EXPERT OPINION AMENDMENT C106 BEVERIDGE NORTH WEST PSP

July 2020

ADDRESS OF PROPERTY: LOT 1 CAMERONS LANE, BEVERIDGE
ON BEHALF OF: BALCON BEVERIDGE PROJECT MANAGEMENT PTY LTD
INSTRUCTED BY: RUSSELL KENNEDY LAWYERS

Waterway Corridor Widths: Overview

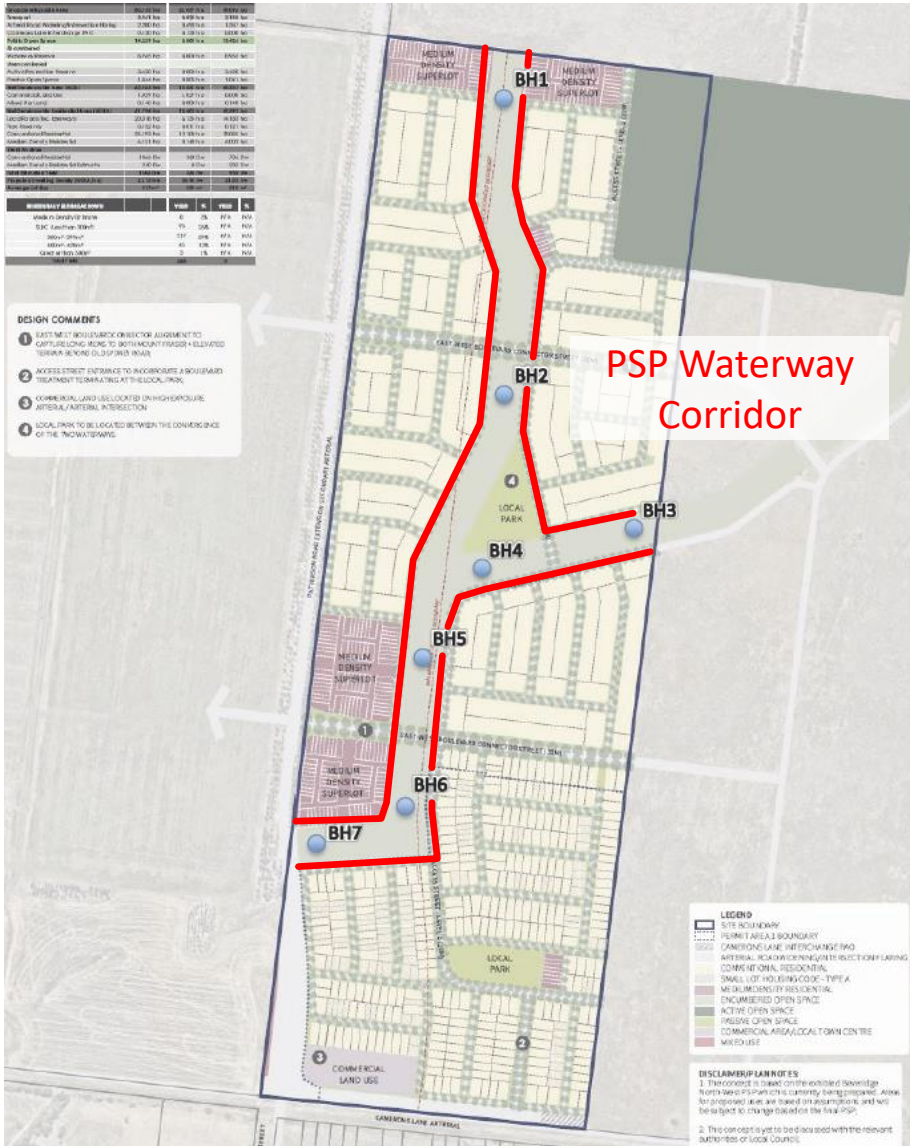
- Proposed reduction in waterway corridor widths within Lot 1, Camerons Lane
- Reductions based on detailed hydrologic and hydraulic modelling

Waterway	PSP Corridor Width	Proposed Corridor Width
Eastern Reach (CH8 - CH7)	50m	37m
Northern Reach (CH5 - CH7)	50m	37m
Southern Reach (CH7 - CH 11)	55m	45m

- Waterway corridor widths proposed are conservative, robust, and not sensitive to changes in the land use budget within the upstream catchment

Waterway Corridor Widths: Dispersive Soils

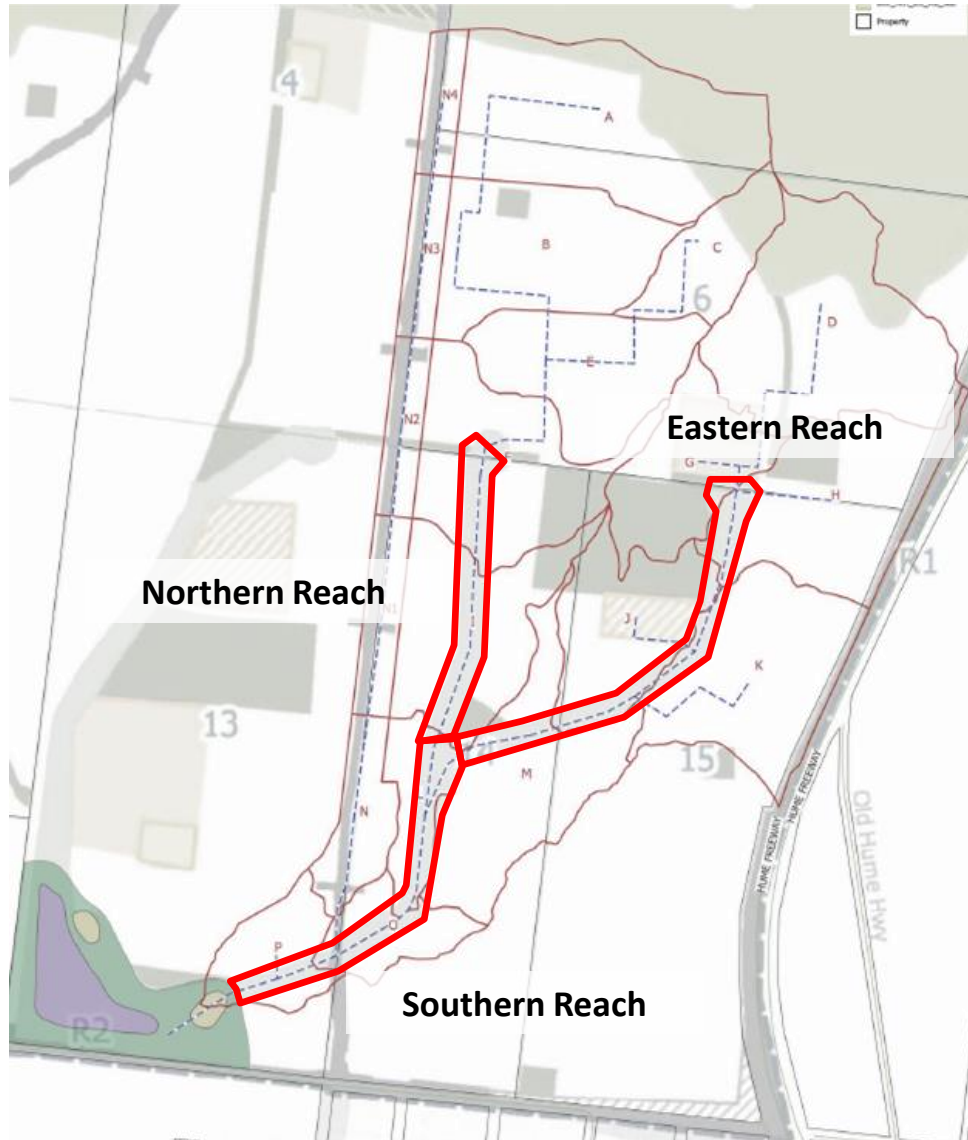
- Geological survey undertaken and assessed by Streamology Pty Ltd on behalf of the Balcon Beveridge Project Management Pty Ltd
- 19 samples taken across 7 boreholes within the waterway corridor proposed within the PSP
- Ground conditions across the sampling were found to be relatively uniform, consisting of shallow, black, self-mulching, medium clays
- Assessment determined that the soils present were primarily Class 3 soils, demonstrating minimal or no dispersion
- Minimal evidence of dispersive soils within the anticipated waterway corridor
- Assessment concluded the waterway corridor consists of non-dispersive soil and therefore dispersion should not factor into waterway width

Waterway Corridor Widths: Hydrology

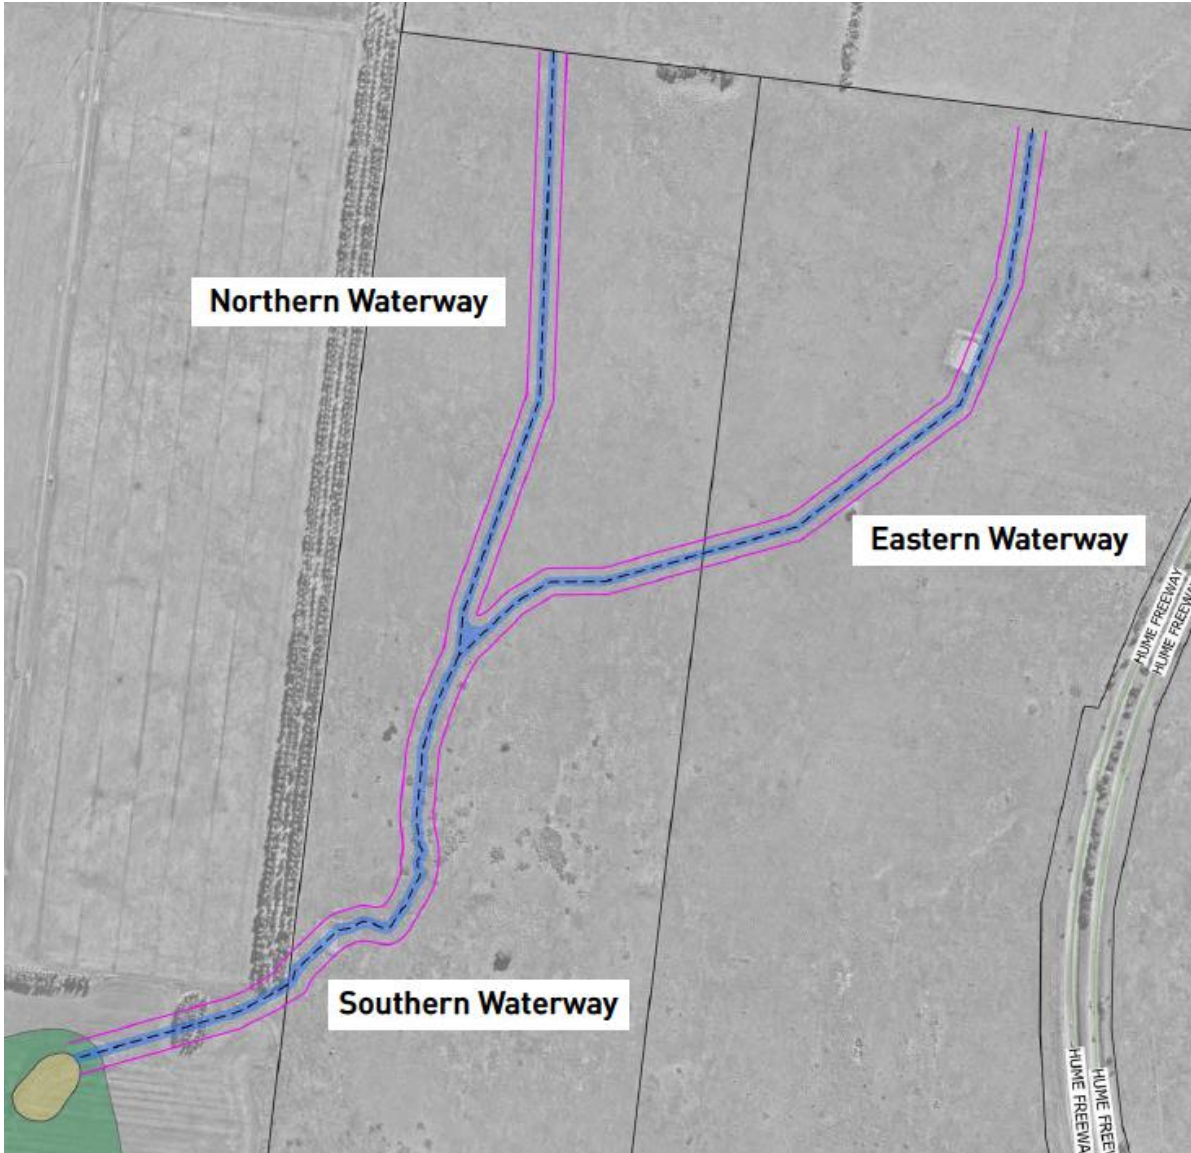
- Melbourne Water Drainage Scheme RORB model reviewed and found to contain some issues, mainly with catchment delineation
- A new RORB model was built by LD Eng for the region using the most up-to-date information and best practice (AR&R 2019) methodologies
- Catchment area reduced by approximately 94.5 Hectares
- Identified 1% AEP peak flow rates were found to be lower across all three reaches

Waterway	Melbourne Water 1% AEP Peak Flow	LD Eng Pty Ltd 1% AEP Peak Flow	Variation
Eastern Reach	15.22 m ³ /s	11.96 m ³ /s	-3.26 m ³ /s
Northern Reach	21.00 m ³ /s	11.36 m ³ /s	-9.64 m ³ /s
Southern Reach	29.98 m ³ /s	25.49 m ³ /s	-4.49 m ³ /s

Waterway Corridor Widths: Hydraulics

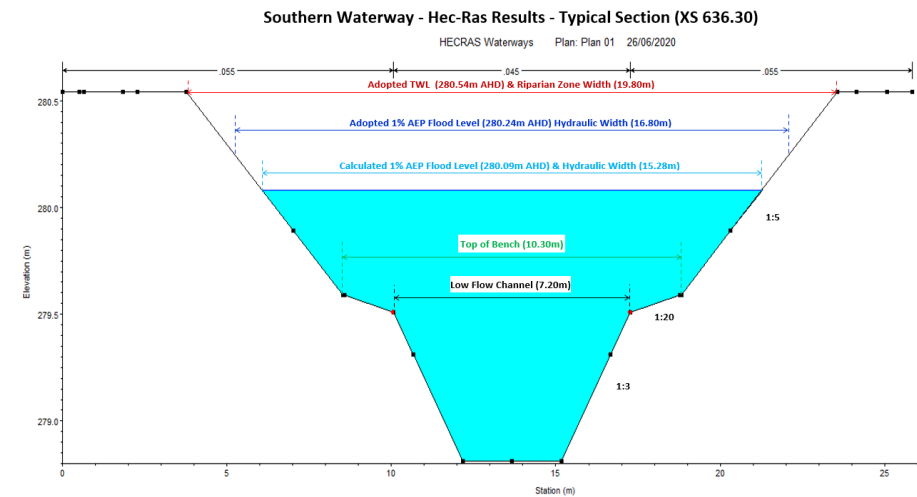
- Waterway profiles designed as per MW “Constructed Waterway Design Manual” (2019)
- Waterway profiles modelled within HEC-RAS & 1% AEP flood extent confirmed to be contained
- Results indicate waterway widths are conservative with between 50 and 150mm more freeboard depth than required by MW

Waterway	Adopted Hydraulic Width	Width incl. Riparian/TWL	Vegetated Offset	Total Corridor Width
Eastern	14.00m	17.00m	20m	37.00m
Northern	14.00m	17.00m	20m	37.00m
Southern	17.00m	20.00m	25m	45.00m

Waterway Corridor Widths: Sensitivity Testing

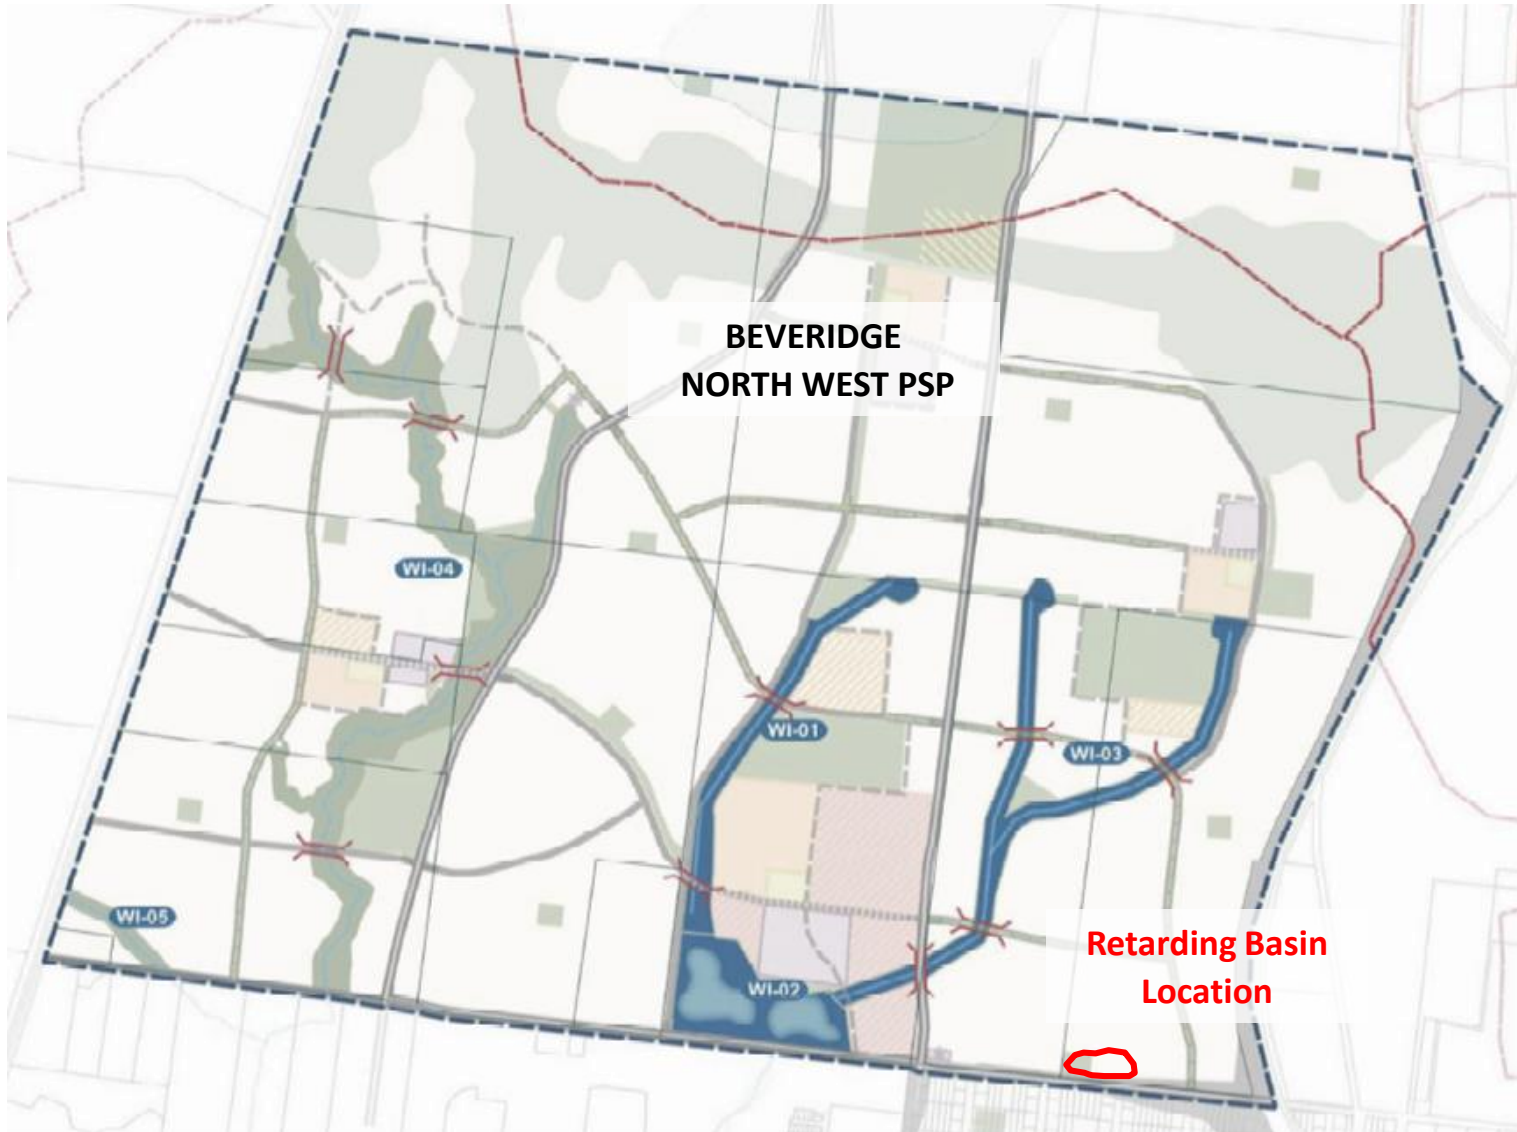
- Additional RORB modelling undertaken to test the sensitivity of the waterway corridor widths proposed to changes in the level and type of development and the land use budget assumed within the PSP
- Fraction Imperviousness (FI) values within the model were increased to 0.65 throughout the catchment - in doing so assuming the region is to be fully developed with no open space or reserves
- As a result water depths within the waterways increased on average by approximately 12.5mm with a maximum increase of 30mm
- Indicates the waterway corridor widths proposed are robust and conservative to a degree where they would not be impacted by any future changes to the Future Urban Structure (FUS) or the assumed Land Use Budget

South Eastern Retarding Basin: Overview

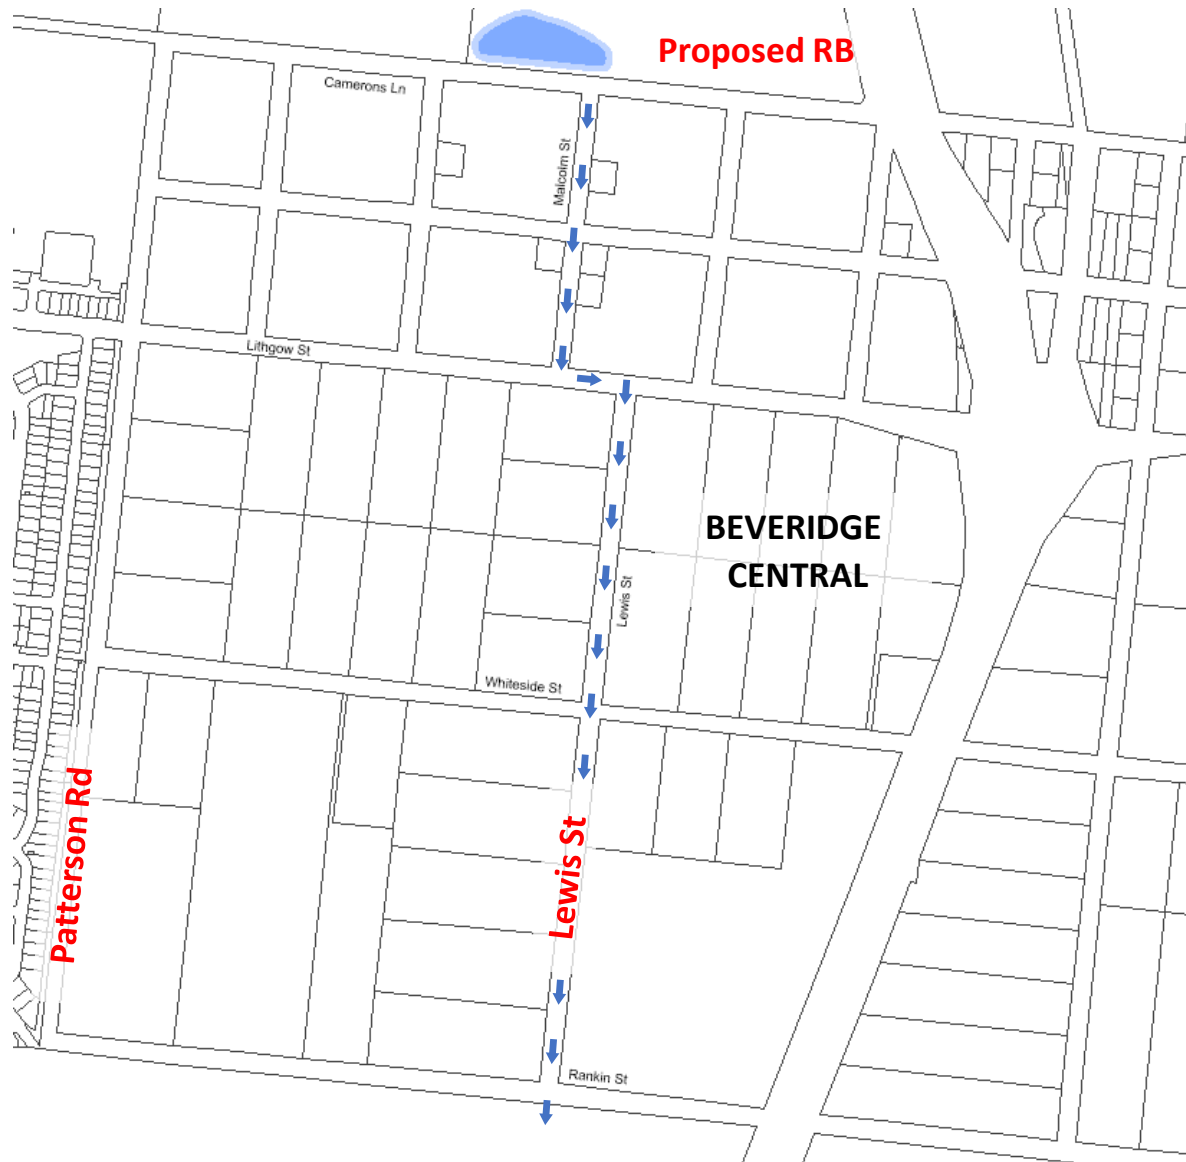
- Inclusion of a 1.5Ha retarding basin north of Camerons Lane
- Basin resides within the BNW PSP boundary & services part of the PSP region
- Reduces 1% AEP peak flows derived from north of Camerons Lane from 15.8m³/s to 1.4m³/s
- Reduces 1% AEP peak flows at outfall of the Beveridge Central region from 34.0m³/s to 14.5m³/s
- This reduction in flow significantly improves the efficiency and viability of the Beveridge Central drainage network

South Eastern Retarding Basin: Hydrology

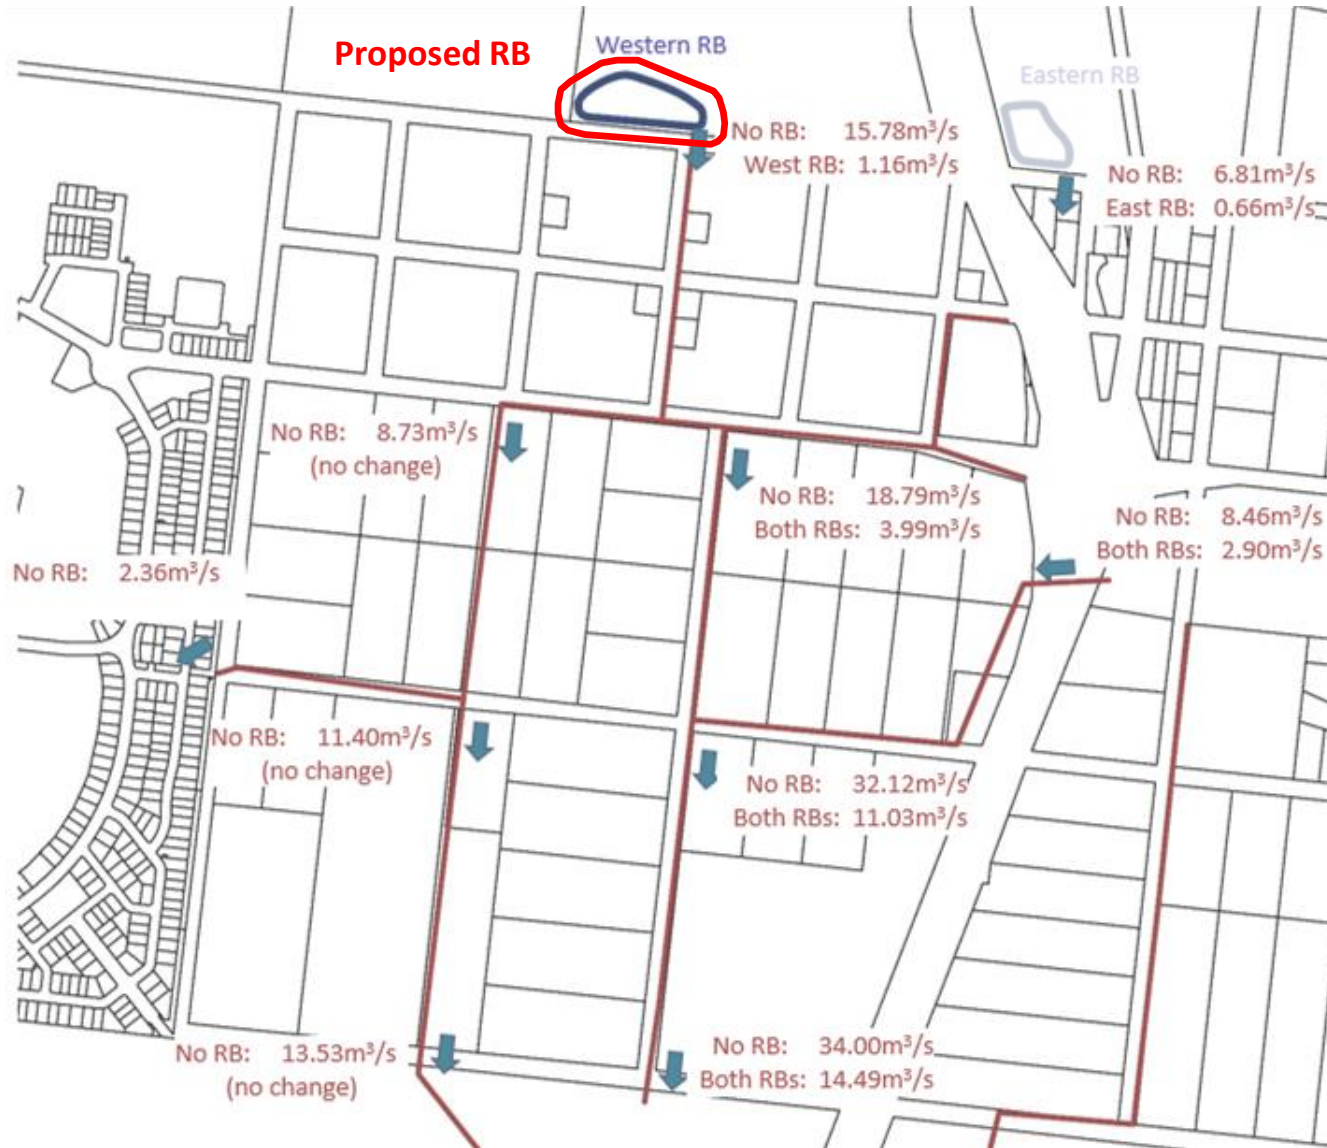
- A new RORB model was built by LD Eng utilising updated topography data and a method of delineating catchments and reaches via spatial queries within QGIS
- The model utilises updated methodologies as specified within AR&R19
- The model includes a retarding basin with a footprint of approximately 1.5 hectares located in the south-eastern corner of the Beveridge North West PSP
- A total storage volume of approximately 17,000 cubic metres including 500mm of freeboard depth
- Peak 1% AEP outflow to the south of Camerons Lane is reduced from 15.78m³/s to 1.37m³/s
